Cliffsend Traffic Calming Proposals and Public Consultation Results

To: **Thanet Joint Transportation Board – 19th December 2013**

By: **Tim Read – Head of Transportation**

Annex 2 Consultation Proposals Plan

Annex 3
Summary of consultation results & comments

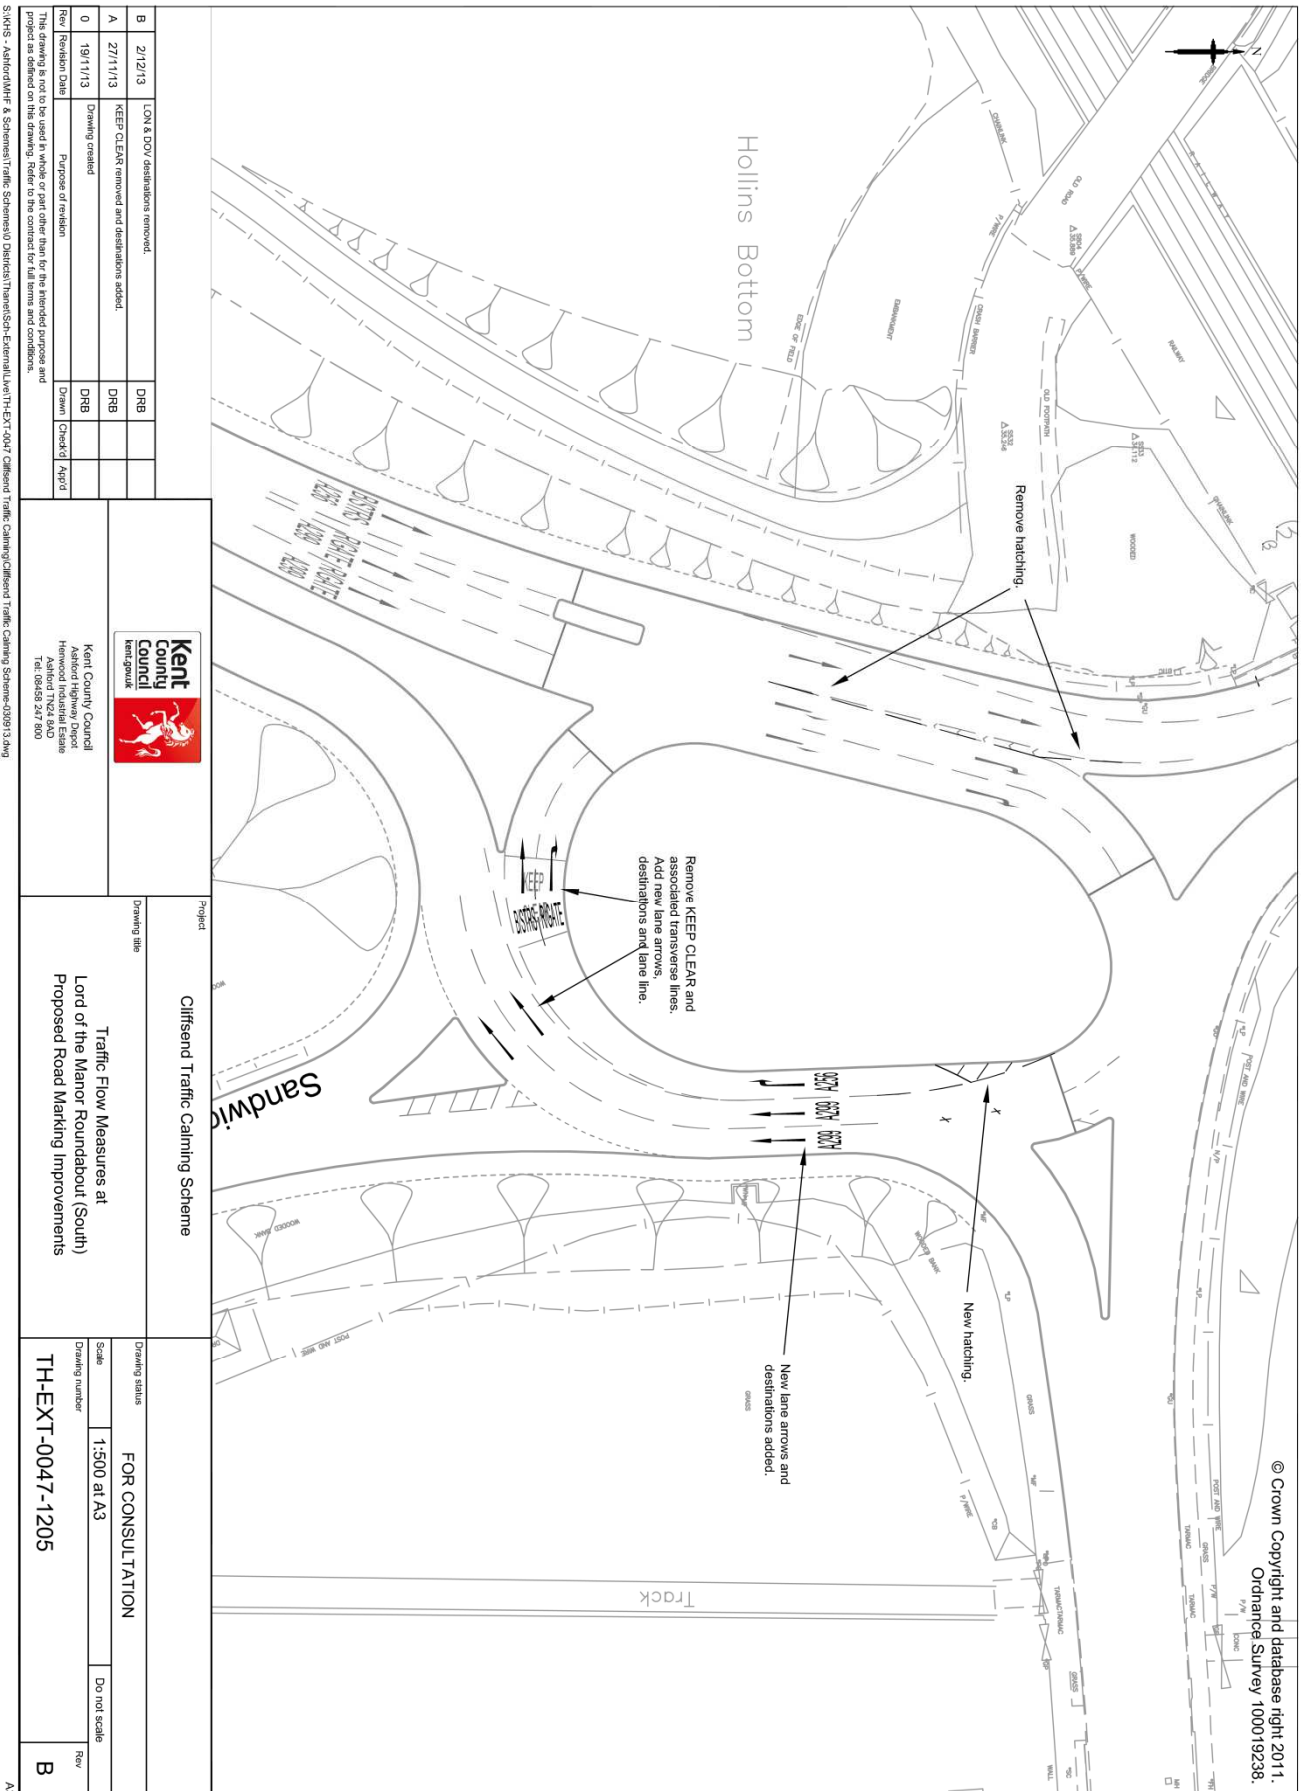
Yes:
All looks good
30 or 40mph speed limit on CRW. New "Cliffsend" village signs.
Better than the dangerous build-outs. Not sure about the signalised roundabout. Can we look at the road markings and signal timings.
Pedestrian crossing on CRW is essential. Need "No Through Road" signs using CRW as a cut through. Is the speed limit remaining at 30mph or is going to be changed to 40mph.
This scheme is needed to slow the traffic through the village
This scheme will help calm the traffic
No mention of the Pegwell end of Foads Lane. The removal of DYL would be a mistake. Congestion has been caused when cars have parked at that end of Foads Lane making entry/exit into Ash Court very difficult. Extending the DYL past the southern water site would help.

7.5t weight restriction needs enforcing. Any plans to alter bus stop at j/w Foads Lane. Not sure road environment is consistent with that of a reduced speed limit, therefore potential non-compliance issue. Need to ensure traffic doesn't start using Foads Hill/Foads Lane as a through route.
Speed Cameras on Sandwich Road. Need improvements to the awful roundabout at the top of Sandwich Road. Use common sense and look at what has not worked elsewhere. Remove islands on both roads
Support in principal. Worried proposed lights will make it difficult for me to get home easily. Existing traffic calming is dangerous. Will road works cause disruption? What about speed bumps?
Add speed cushions as well
Can we remove all unnecessary signage and cones when we are done
Proposals are welcome. Concerned that residents near Viking ship do not have to navigate round the village to get to their homes
Confused about Haine Road junction. Live in Mount Green Ave so would come down hill past Viking ship to get home from Haine Road. So do they have to go along Hengist Way or can they go through top part of village (CRW). Traffic has become bad again.

Not sure about parking in CRW. Obstruct access from side roads. Why still 50mph limit on part of CRW. Appreciate closure of turn into Cliffsend from Haine Rd but this will cause tail backs.
Buildouts are a traffic hazard and a cause of many problems.
This should have been done before new road opened. Close Sandwich Road to through traffic at Ebbsfleet lights.
100% agree with proposals. Traffic on Sandwich Rd has increased again.
Could have turned the traffic lights off at LOM Rbt. Proposals are favourable
Like it. Alternative would be to give all road entering onto Sandwich Road & CRW

Overall support for plans. Concerns about the current 50mph on Canterbury Road West, 30mph would be preferable. Enforcement is required. Clearer signage is needed prior to CRW and Sandwich Road. Signalled gateway is having a definite effect, well thought out. Look forward to the one proposed for Sandwich Road. Narrowing of CRW with footways will add to narrowing of road. Do not remove yellow lines please.

CRW: Blocking of roundabout has had an effect to a degree. Removal of the buildout was essential as was in the wrong place and a danger. It would have been better to relocate it to other side of water works entrance to slow traffic. Trial signals had limited effect and encouraged cars to speed. Do not remove the build out by Jentex as it is the only safety valve to stop cars speeding. 30mph limit needed all along CRW. Flashing speed sign and roundels needed. Signage needs addressing. Sandwich Road: Reduce speed limit from Lof Manor. Anything to stop traffic overtaking is welcome. Installation of traffic lights at the garage should help but needs to give precedence to outgoing traffic. Both roads: No point in removing clearway orders. Don't understand why hatch markings not continued for whole lengths.

Sandwich Road: Speed Limit reduction - very pleased but needs enforcement. Extend 40mph to Ebbsfleet. Not supportive of removal of double yellow lines. Remove lines on coastal side only. Supports roundabout exit narrowing's, raised table, moving of bus stops, gateways, part closure of roundabout & traffic signal gateway. Would like lights at both ends. Re-phase Ebbsfleet lights to have more red time on Sandwich Road. Not sure mini roundabouts will work. Need "No through traffic signs". Keep build outs.

Need to raise mini roundabouts so motorists can't drive straight over them. Doesn't like raised platforms as degrades car suspension. Speed camera would be preferable. Likes the idea of the signalised gateway but thinks could split into chicane slightly further out and incorporate a puffin in the lights and locate at Foads Lane. Believes white hatching to be a waste of money if to prevent overtaking.

Sandwich Road: Pleased to see speed limit reduction but needs to be enforced. Concerned about the removal of parking restrictions as may encourage indiscriminate parking. New lane markings needed on traffic signalled roundabout. Traffic signal gateway near petrol filling station is a good idea.

No:
No exit to CRW from Haine Road will cause congestion. Look into the signing
Very poorly thought out. Already wasted thousands installing/un-installing raised table junctions. Leave Cliffsend alone. Use money for road repairs. 30mph limit needed. Scheme will ruin the village not improve it. Do not want obstructions.
Allowing on street parking between Cliff View Rd and Sea view Rd will restrict visibility when exiting onto CRW. Where is bus stop being moved to?
Ridiculous expense. Sandwich Road from Canterbury Road will be chaotic; a blockage at the rbt, then mini-rbts for what, traffic will be less so they won't be needed. More traffic will flow along Hengist Way causing more chaos.
Take away priority workings as they create the race track. Remove the ridiculous traffic light system from the new roundabout. Leave access to Cliffsend from alone, will cause problems for residents. Do not need a gateway with islands. No traffic calming measures needed, just a pelican on on CRW. Where are the noise reduction trees that were promised? WANTS A RESPONSE TO HIS QUESTIONS

Closure of exit from LM Rbt will increase journey time for residents.
Wants to know where the bus stops are going to be moved to
Going to make resident entry/exit from Cliffsend much worse. To narrow the exit of the rbt is an accident waiting to happen. Making traffic use the signal roundabout will make things worse
Speed humps and both Sandwich Rd & CRW would have solved the problem. They are prisoners to Haine Rd. The cost is unjustified and unnecessary.
With the new road there is no longer a speeding problem. Build-outs have not calmed the traffic and are dangerous. Signalised gateways will predominantly show red for residents exiting Cliffsend. Whole scheme seems to be not required and a waste of money. There is not a problem.
Not allowing traffic onto CRW from Haine Rd will cause increased traffic problems.
Trying to make life difficult for residents. Would question the safety of allowing parking on CRW and Sandwich Rd. Removing laybys just make buses a further hazard

Dangerous to close exit onto CRW from as Haine Rd Rbt is always a problem. Short green times, lane changing by vehicles. More traffic goes through the village than use the bypass to miss all the restrictions.
Changes unnecessary and another inconvenience to the motorist. Spend money on potholes.
Buildouts are dangerous on CRW and should have speed cushions.
Can't believe we are proposing yet another major road project. Objecting to the closure of CRW from Lord of the Manor Rbt.
Reduction of speed limit on Sandwich Rd is a good idea. Do not need 2 mini roundabouts or moving the bus stop. A pelican crossing would have been a sensible idea, near the pub or Viking ship. Distinct feeling of certain groups wanting to rid Cliffsend of any outside intrusion.
Object to closure of CRW from Lord of the Manor Rbt. Need footpaths from LOM rbt to Jentex.
More to stop speeding traffic. 30mph speed limit through CRW to LOM Rbt and 20mph on all roads through the village. If suggestions are included then would support the proposals. Closure of Foads Hill at Level Crossing would be better option to stop rat running.

Speed cushions from Ebbsfleet through to LOM Rbt
Enforce the ban on large vehicles on CRW. Leave alone as it works well as it is.
Leave build out by Chalk Lane. Put islands instead of mini roundabouts. Need a crossing by Foads Lane. Extend 30mph limit to nature reserve.
Objects based upon longer response times for emergency vehicles. Believes a better solution would be average speed cameras.

Not agree with Sandwich Road proposals as will result in additional queues. Agrees the by-pass is not currently used effectively. Why not use average speed cameras with 30/ 20 limit. Road markings at Lord of the Manor need reconfiguring.
